December 3, 2024

Jenny Baez, NYSDOT
Scott Geiger, WSP

Appendix

Rt 9 @ Beekman Ave (S proposed, facing S)

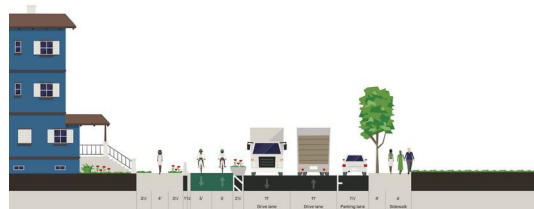
42 feet wide from curb-to-curb, an appropriate amount of space for carrying two motor vehicle lanes, a parking lane and a barrier protected mobility lane on the east side. (See the Chestnut Street diagrams on line: [existing](#), [proposed](#). The Korean Church area cross sections are available at right and below, as well as online: [existing](#), [proposed](#).) And outside that width, room is available for sidewalks on both sides. With these modifications, taking land or cutting down trees is unnecessary.
